Your reference: EPML00392513; 101/0008114

Re Information Request Notice Response for PRC Plan for ML10279 and EPML00392513

Attachment to PRCP Information Request Response

Figure 1 Topsoil and Overburden stockpiles from initial pit development (Plan of Operations)

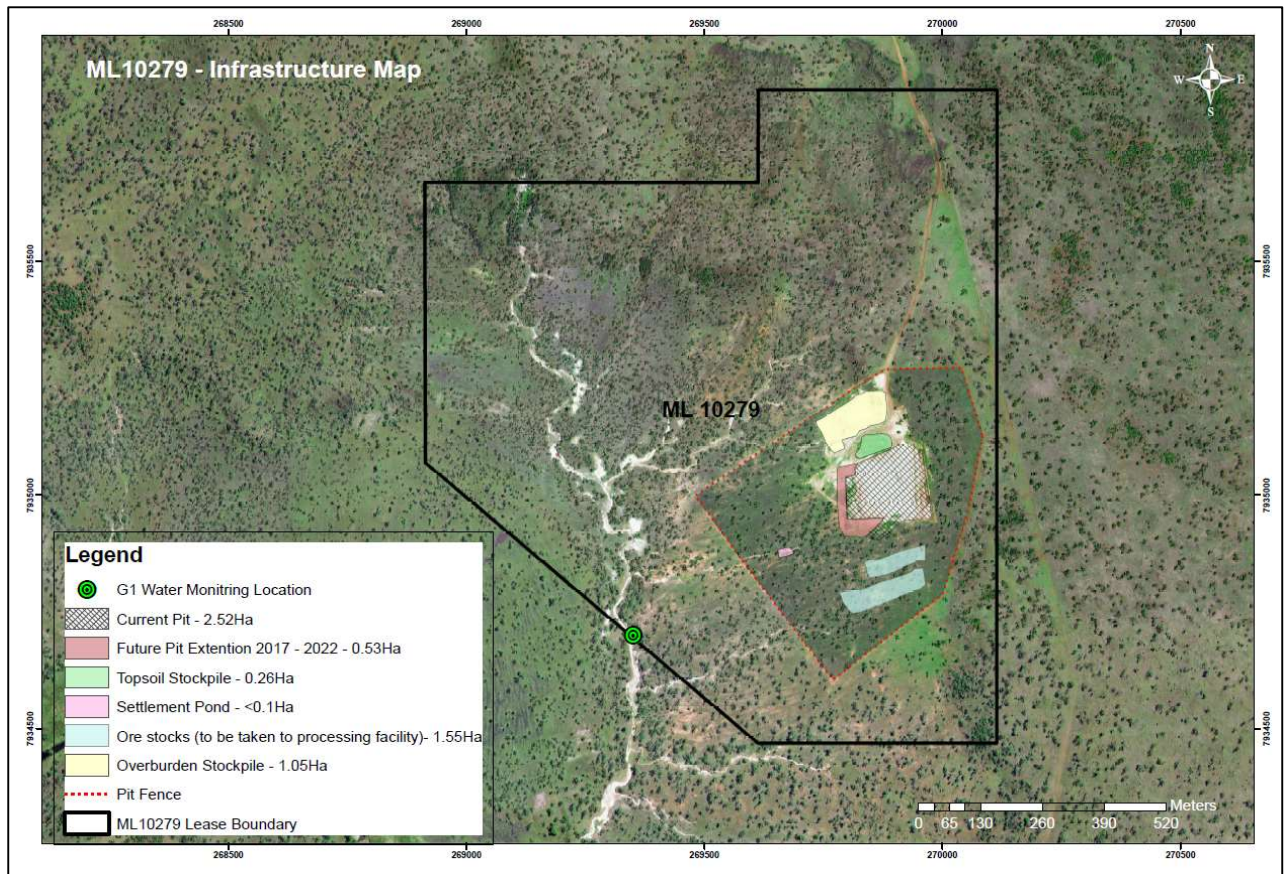
Further detail on methods of sourcing soils

The site plan (Figure 4 of soils from PRCP) illustrates the boundary of soil types. Furthermore the physical description of those soil units (as described in Appendix 3 and reproduced in [Table Table 2](#) below) will be used to dictate the depth of topsoil to be stripped prior to disturbance for pit development. The volumes have been presented by soil type and disturbance footprint to demonstrate that soils can be yielded in sufficient quantities to achieve rehabilitation milestones.

Sequence of soil preparation and how it is achieved

1. Topsoil to be stripped over surface and stockpiled separately from subsoil storage.
2. Stored topsoil to be kept to a minimum height (<2m)
3. Stored free from traffic and erosive agents.
4. Stockpile to be sown with cover grass seed from revegetation mix and maintained weed free until use in backfilling and surface revegetation.
 - Topsoil stockpiles should be used in order of creation, that is oldest stockpiles should be used first.
 - Initial pit areas to be removed to stockpile area (Figure 4 from current Plan of Operations) to be used in backfilling sequence.
 - Later topsoil yield can be applied directly to backfilled pit areas and sown with revegetation mix directly.
 - A minor stockpile to be maintained from final pit (Pit 5) to use in that pit's backfilling and surface revegetation.

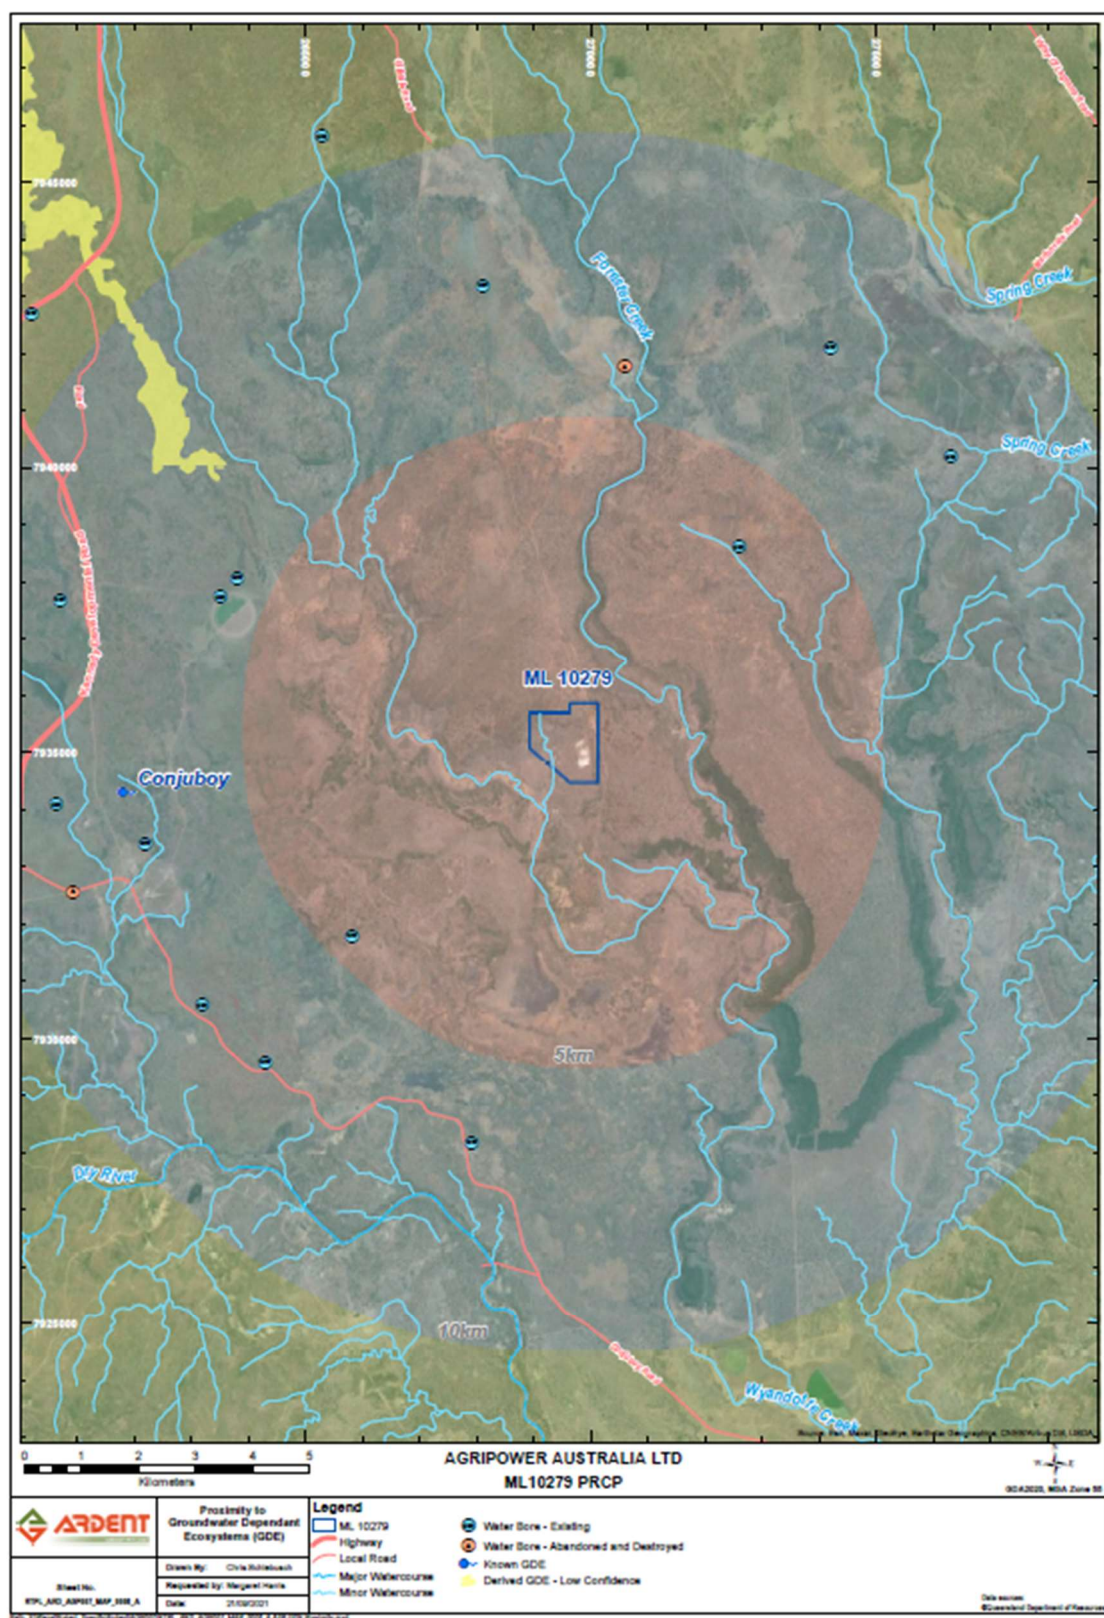
(a) potential interaction with groundwater

Proposed Insertions: Insert into section 5.1.1 including Figure

The target ore zone has been characterised as an aquitard. The backfilled material will be largely within C6 ore zone (i.e. diatomaceous earth) at least 2 metres from the ore zone floor. It is not expected that there will be vertical infiltration through the backfilled material into the underlying basalt aquifer but will behave consistent with the other surrounding basaltic overburden material.

Figure 11 shows the nearest groundwater dependent ecosystem (GDE) of record is 7.45km west of the pit extent at an elevation of 521m. The pit development and rehabilitation will not have an effect on this location due to the aquifer divides that occur between the pits and this location. Adjacent landholder bores for agricultural supply are more likely to have effect on the mapped GDE area.
